TENNESSEE VALLEY AUTHORITY
BROWNS FERRY NUCLEAR PLANT (BFN)
Units 1, 2, and 3
DOCKET NOS 259, 260, and 296

PROPOSED TECHNICAL SPECIFICATION (TS) CHANGE TS-395
DESCRIPTION AND EVALUATION OF THE PROPOSED CHANGE

Fig 1
RESIDUAL HEAT REMOVAL SERVICE WATER (RHRSW) SYSTEM

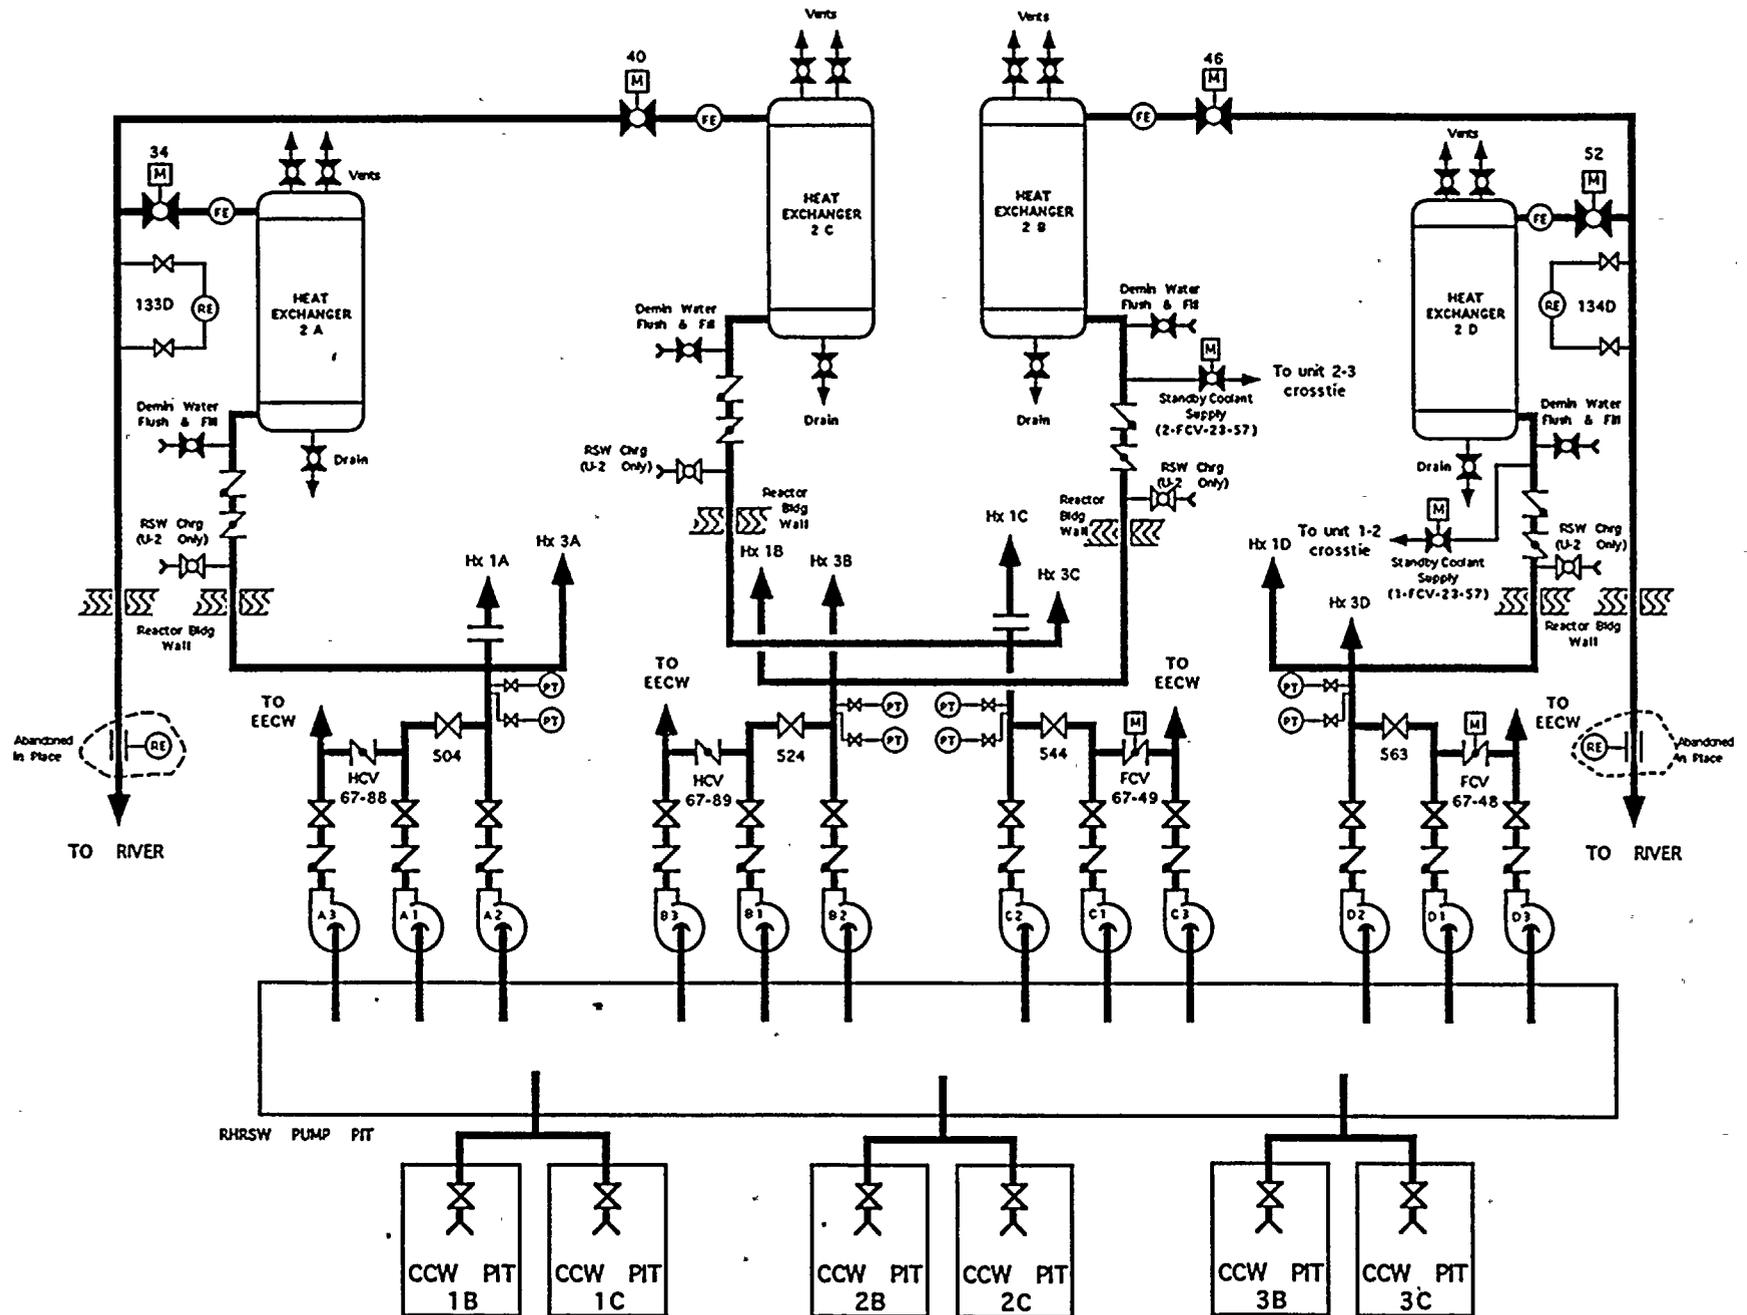
The normal configuration of the electrical supplies for the eight RHRSW pumps normally assigned to the RHR service water system (Refer to the system description below) includes four pumps (B1, B2, D1, and D2) each supplied from separate 4KV shutdown boards (3EC, C, 3ED, and D, respectively). The emergency power supply configuration includes four corresponding separate diesel generators (3C, C, 3D, and D). Two pairs of

RHRWSW pumps (A1, A2, and C1, C2) share common 4KV shutdown boards (A and B) and diesel generators (A and B), respectively. The RHRWSW pump power supplies are shown on Figure 1. The current technical specification allows RHRWSW pump alignments to be selected which could result in the loss of two RHRWSW pumps assuming a single failure of diesel generator A or B. The loss of two RHRWSW pumps, depending upon the number of operating units, could result in less than the number of operable RHRWSW pumps required to support the RHR cooling function.

The proposed change ensures that the RHRWSW system is operated in a manner which increases the power supply diversity of the system by requiring an additional pump be operable unless each pump selected to satisfy the operability requirements of Specification 3.5.C is supplied from a separate 4KV shutdown board. The practical effect of the proposed change is to require an additional operable pump whenever RHRWSW pumps A1 and A2 or C1 and C2 are selected.

Figure 2
 RHRSW/EECW POWER SUPPLY DEPENDENCIES

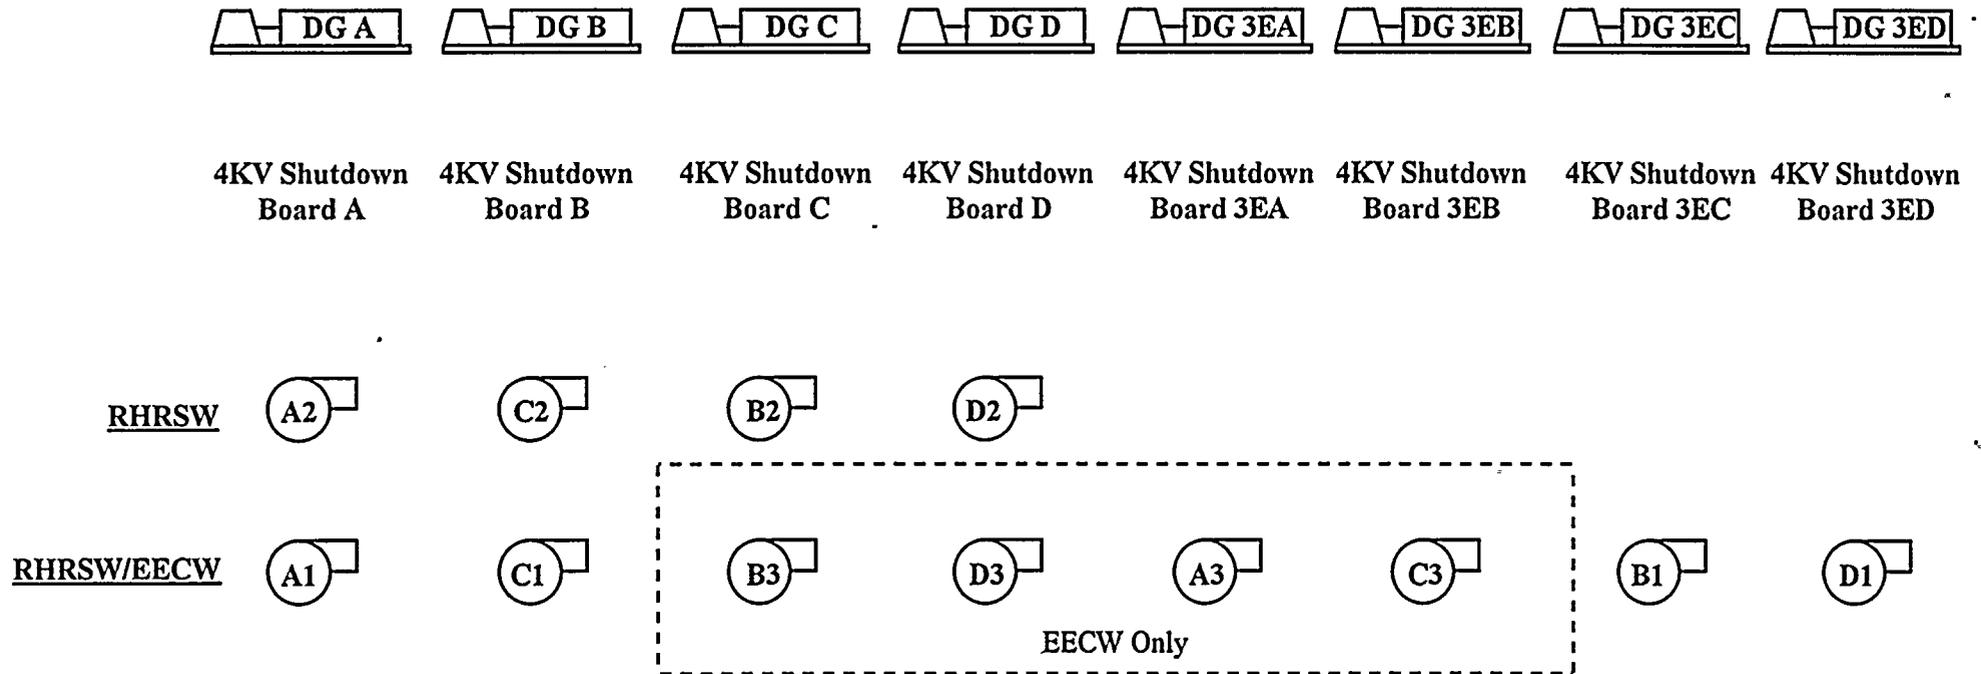
The RHRSW system is a twelve-pump, four-header system with four pairs of pumps (A1, A2, B1, B2, C1, C2, D1, D2) normally assigned to the RHR System and four additional pumps (A3, B3, C3, D3) normally assigned to the EECW System. The RHRSW system is shown on Figure 2. Each of the pairs (assigned to the RHRSW System) feeds one independent RHR service water header which, in turn, feeds one RHR heat exchanger in each unit. The four pumps assigned to the EECW are also paired, one pair serving each of the two EECW headers. If necessary, one of each pair of pumps normally assigned to the RHRSW (A1, B1, C1, D1) can be manually realigned to the EECW. These pumps are termed "swing pumps." The entire system is seismic Class I. On a per-unit and per-plant basis, the system provides several ways to supply water to the required heat loads. Each RHR service water and EECW header is physically, mechanically, and electrically independent of the alternate headers performing the same function.

The proposed changes are acceptable from a nuclear safety standpoint since they ensure the RHRSW system's ability to perform its safety functions with a single failure under the worst case pump alignment conditions, and do not place any additional burdens on the operators. TVA's proposed TS change assures the minimum number of RHRSW pumps for both the accident and non-accident unit(s) are available considering the worst case single failure.
